UNITED STATES PATENT AND TRADEMARK OFFICE

Office Action Summary

10/668,734

TOBEN ET AL.

FIG. 4

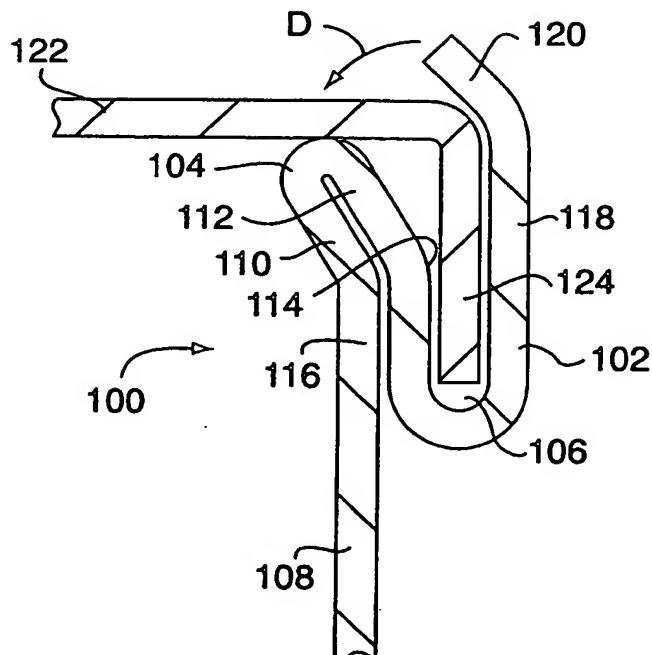
The drawings are objected to as failing to comply with 37 CFR 1.84(p)(4) because reference characters "108" and "116" have both been used to designate the same duct wall in Figure 4.

Corrected drawing sheets in compliance with 37 CFR 1.121(d) are required in reply to the Office action to avoid abandonment of the application. Any amended replacement drawing sheet should include all of the figures appearing on the immediate prior version of the sheet, even if only one figure is being amended. The figure or figure number of an amended drawing should not be labeled as "amended". If a drawing figure is to be canceled, the appropriate figure must be removed from the replacement sheet, and where necessary, the remaining figures must be renumbered and appropriate changes made to the brief description of the several views of the drawings for consistency. Additional replacement sheets may be necessary to show the renumbering of the remaining figures. The replacement sheet(s) should be labeled "Replacement Sheet" in the page header (as per 37 CFR 1.84(c)) so as not to obstruct any portion of the drawing figures. If the examiner does not accept the changes, the applicant will be notified and informed of any required corrective action in the next Office action. The objection to the drawings will not be held in abeyance.
